## **CULTURAL HERITAGE COMMITTEE AGENDA REPORT**

**SUBJECT:** REVIEW OF THE REPAIR AND RENOVATION OF THE ALLEN HOUSE (MASTER LIST HISTORIC RESOURCE), INCLUDING REPLACEMENT OF WINDOWS; INSTALLATION OF SKYLIGHTS WITHIN THE BUILDING ROOF; AND REMOVAL OF A ROOF CANOPY AT THE REAR OF THE BUILDING, AND ITS REPLACEMENT WITH

**PROJECT ADDRESS:** 1700 Osos St.

**FILE NUMBER:** ARCH-0145-2021

**Figure 3: Patio cover to be demolished (left); replacement deck (right)**

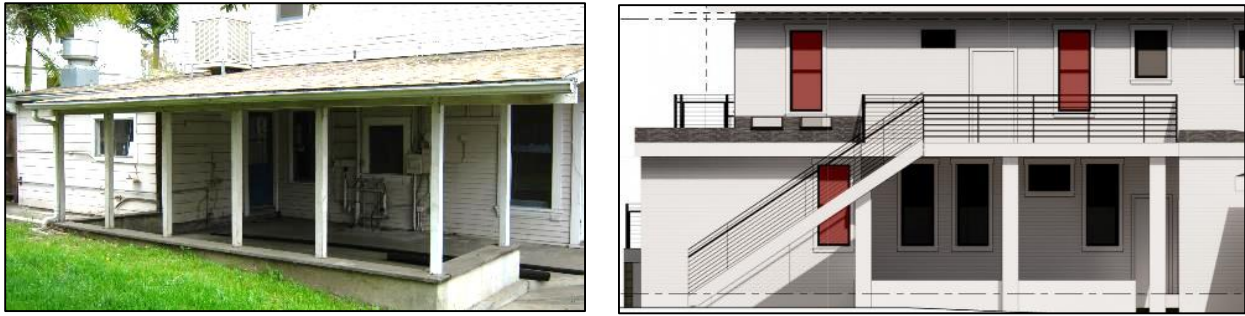
Patio Cover and Deck. At the rear elevation, a patio covering is proposed to be removed, to be replaced by a new second-level concrete deck structure with metal guardrails that will also provide a ground-level covered patio area (see Figure 3).

**Discussion:** The proposed deck, rebuilt stairways, and “fire riser pop-out” are sited and designed in a manner intended to preserve the integrity and historical character of the building. The deck is placed at the rear elevation and is limited to a single story in height, with deck and guardrail above, in replacement of an existing patio cover. The concrete deck and stairway materials and metal guardrails are compatible in appearance with the building’s wood siding and trim materials, and the deck and stairways are well-integrated into the building form. The new “pop-out” is on the least visible elevation of the building.

As discussed earlier in this report, the proposed new deck is on the lower level of the rear building elevation, integrated with the building form and composed of compatible materials, so as to avoid negative impacts to the building's historic character.
